**Subject:** **Review and Comment on Treatment of Subsidence in Draft Tule Subbasin  
Groundwater Sustainability Plans, Particularly in the Vicinity of the Friant-Kern  
Canal**  
(EKI B60064.03)

Re: Subsidence-Focused Review of Tule Subbasin Groundwater Sustainability Plans  
For Friant Districts in Kern County

**Figure A1-8 from the Tule Subbasin Monitoring Plan (Attachment 1 of the TSCA)**

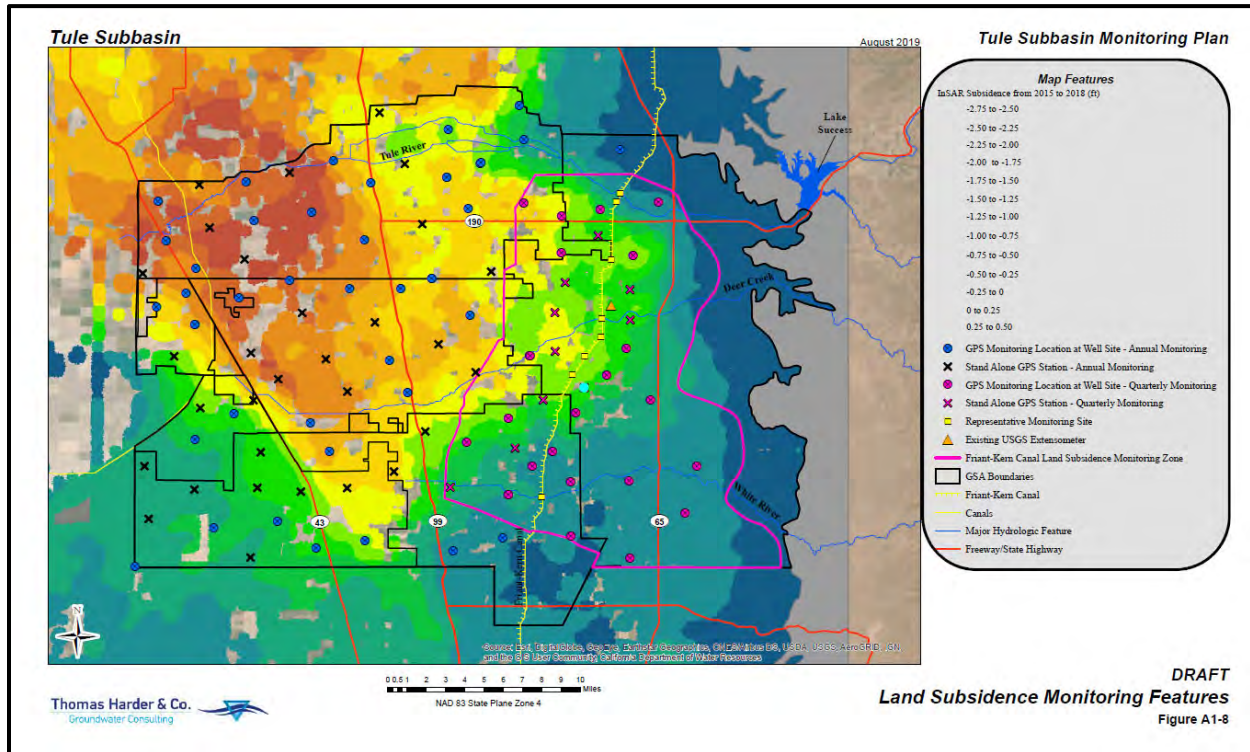
*Comment: The Monitoring Network for subsidence in the vicinity of the FKC is inadequate.*

Figure 6-3 from the ETGSA GSP

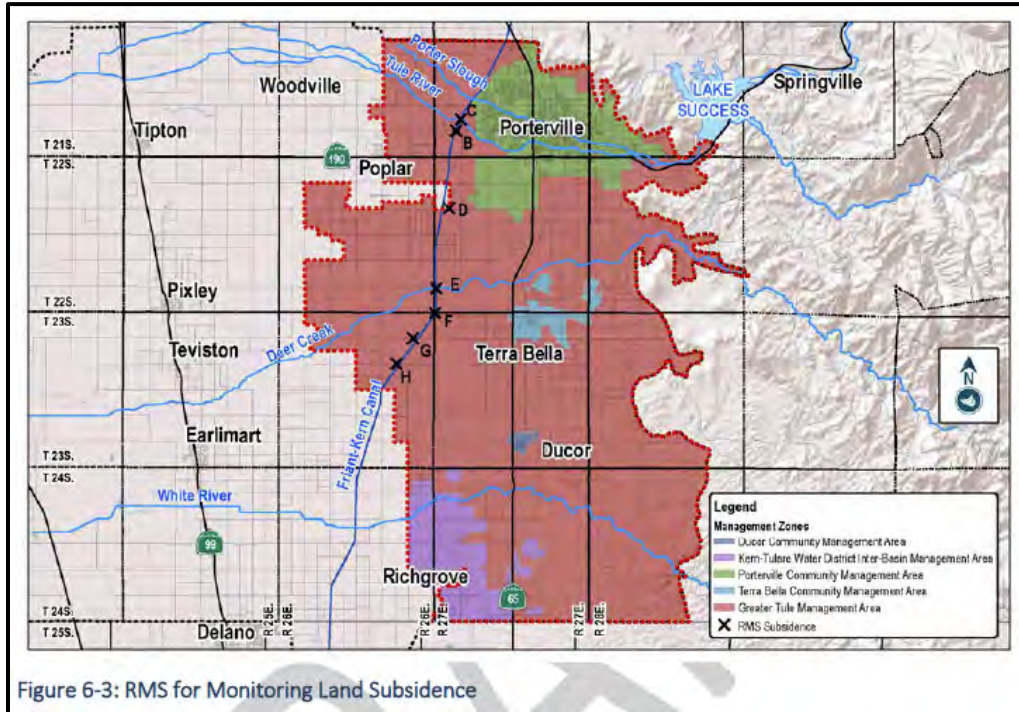
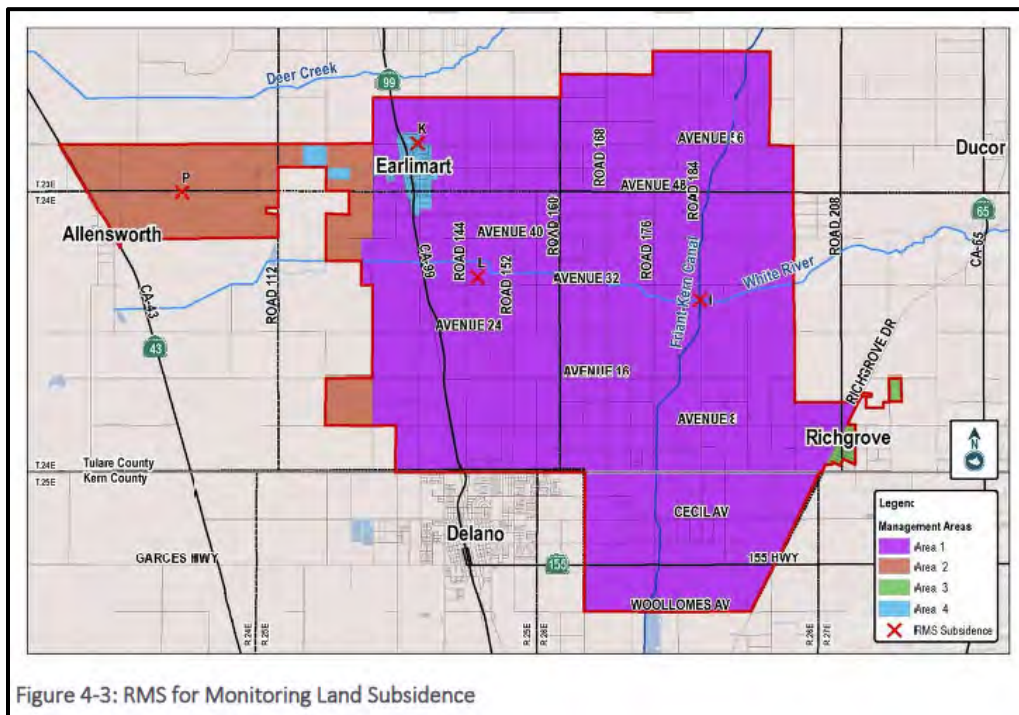
Adjacent GSPs: The DEIDGSA GSP monitoring network (Section 4.2.3.5) only contains a single RMS along the FKC, which provides inadequate spatial resolution to capture the details of subsidence in the DEIDGSA area. The GSP Regulations 23 CCR § 354.34(f) requires that the Agency “determine the density of monitoring sites and frequency of measurements required to demonstrate short-term, seasonal, and long-term trends based upon the following factors ... (3) Impacts to beneficial uses and users of groundwater and land uses and property interests affected by groundwater production, and adjacent basins that could affect the ability of that basin to meet the sustainability goal.” Given that the DEIDGSA GSP monitoring network only contains a single subsidence RMS along the FKC, the network will not allow for sufficient characterization of impacts to overlying land uses (i.e., including critical infrastructure such as the FKC) and impacts to adjacent basins. As such, the subsidence monitoring network does not appear to satisfy the requirements of GSP Regulations 23 CCR § 354.34(f).
